Subject: Montana Creek Master Plan

Subj: JNSC comments and questions regarding the August 10<sup>th</sup> publication of the “Montana Creek Master Plan” maps and video presentation.

CBJ (and the other management agencies) presented a preliminary “plan” at the Aug 10<sup>th</sup> meeting in the form of two maps. We view these maps as preliminary concepts rather than constituting an actual plan. Currently, the online video of the meeting and slides are the only background information regarding the maps that is currently available. Without supporting narrative and background information, it is difficult for us to know who or which agency proposed a specific trail, cabin, parking area etc. and the rationale behind the choices. However, based on email exchanges with Michele Elfers, we understand that the intent of management agencies is obtain comments on the preliminary maps from interested parties, which would then be used as part of an iterative process to formulate the eventual master plan. In that spirit, JNSC is pleased to offer its comments and advice on the “plan” and hope that they will be considered and incorporated. Because the master plan maps lack any supportive materials

Figure 1. Current Montana Creek groomed trail (MCR, red). Also shown are several proposed additions and connector trails (yellow). WGL = West Glacier Loop (yellow); MMSC = MMS connector trail (black); and MV = McGuinness Valley loop trail (orange) (adopted from the JNSC Trails Development Plan).

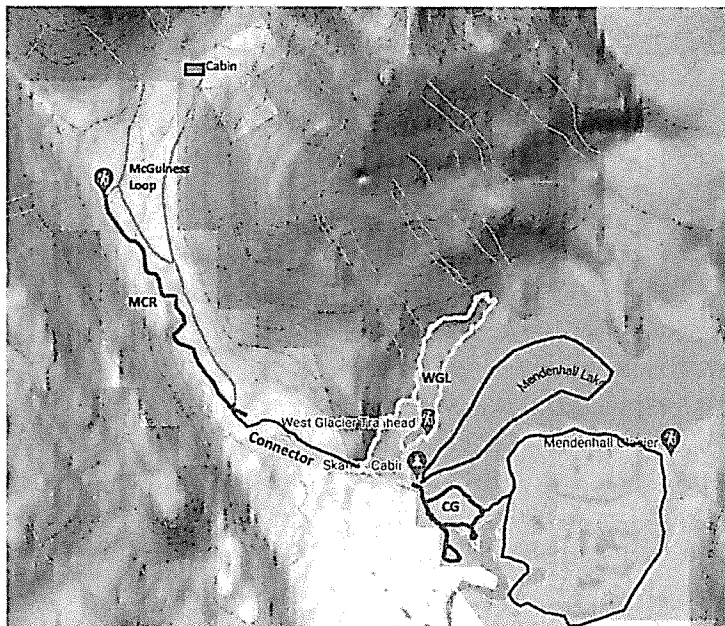
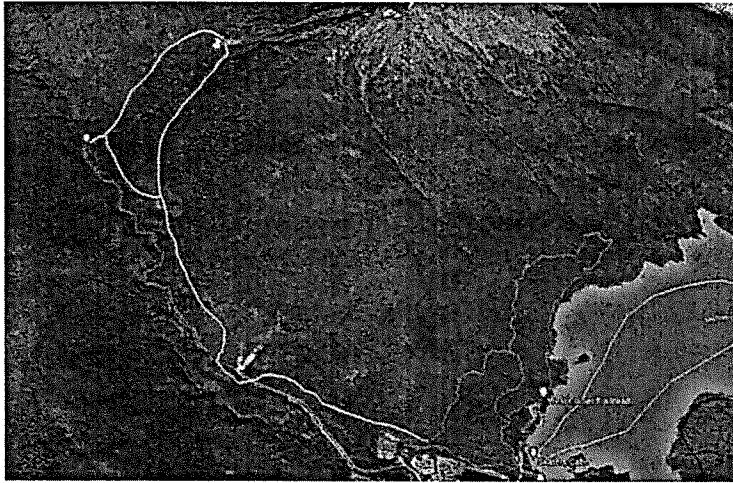
In the Aug 10 video narration, “loop” trails were held up as being particularly attractive features for trail development. The trail system depicted in Figures 1 and 2 offer multiple different loops: a) the McGuinness Valley loop; b) the Montana Creek loop, combining trails on either side of the river; and c) the entire Montana Creek – McGuinness Valley loop. These loops and trails would have great appeal for skiers, hikers, and bikers and also provide access for ski touring and ski mountaineering in the upper McGuinness Valley. We insist that the added trails be for non-motorized users only!

Figure 2 also shows the potential location of a recreational use cabin in the valley. The desirability of such cabins was emphasized in the Aug 10 meeting and this would be a perfect location for one, either on USFS land or adjacent CBJ land.

The construction of the Montana Creek and McGuinness Valley Nordic loop ski trails can be staged over time with the eastside trail parallel to Montana Creek given a five-year goal of achievement and the McGuinness Valley loop and recreational cabin designated as part of a ten-year goal for the plan.

Such a connection is integral to the JNSC Nordic Ski Trail Development Plan. We are encouraged that both of the CBJ MP maps show an interconnect to the MGRA trail system, similar to what was presented in the JNSC trail plan. Figures 1 and 2 show the potential location of such a trail in much more detail (Figure 1, black; shown as orange in Figure 2). We suggest development of this interconnect be given highest priority as most of it occurs on CBJ land, with construction commencing within the next two years following plan approval.

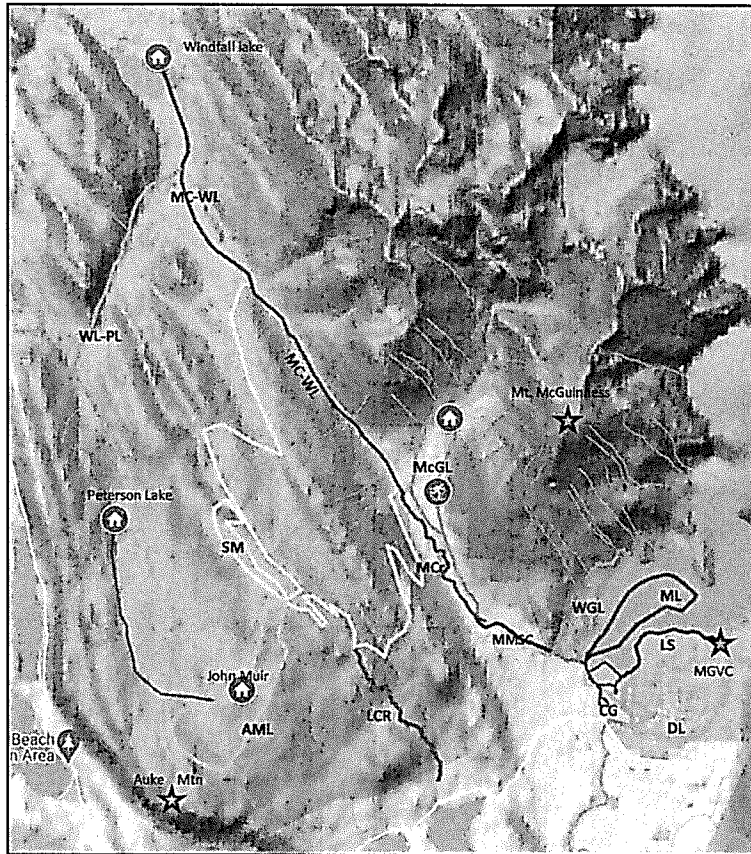
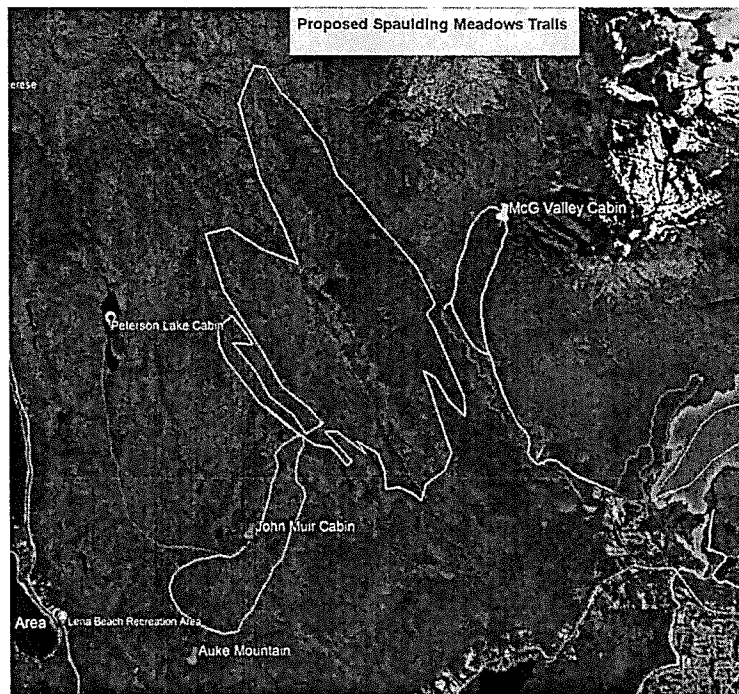
Development of a Nordic Trail system in the Spaulding Meadows non-motorized sector (as shown in Figures 3 and 4) is the key feature in the ten-year goals of the JNSC trail plan. It is therefore disappointing that this trail system was not included in the preliminary CBJ M Cr MP maps. As explained in the JNSC trail plan, development of this trail system is a key component in providing Nordic skiing opportunities as climate change and regional warming intensify. JNSC requests that the trails outlined in Figures 3 and 4 (yellow) be included in the next iteration of the M Cr MP.

Another priority is to develop a road to Spaulding Meadows that would create a trailhead at higher elevation, approximately ~ 400-460 m (~1300 to 1500 ft), where snow falls earlier and remains longer (Fig. 3). JNSC sees construction of a road to Spaulding Meadows as an important opportunity for maintaining accessible Nordic ski trails for the general public as climate change continues. JNSC seeks to partner with the Juneau Snowmobile Club to make this improved access and equity to Spaulding Meadows a reality for both user groups.

JNSC supports inclusion of this winter ski and snowshoe spur trail as shown on the master plan maps. We include it in Figures 3 and 4 (magenta) as an extension of our proposed Auke Mountain Loop. The trail to Peterson Lake is already marked and periodically used by the ski-touring community. Better signage and trail development would make this option of cabin to cabin skiing even more attractive. However, JNSC wants to emphasize that the leg to Peterson Lake is a “ski-touring” trail and not a trail we would normally groom for Nordic skiing.
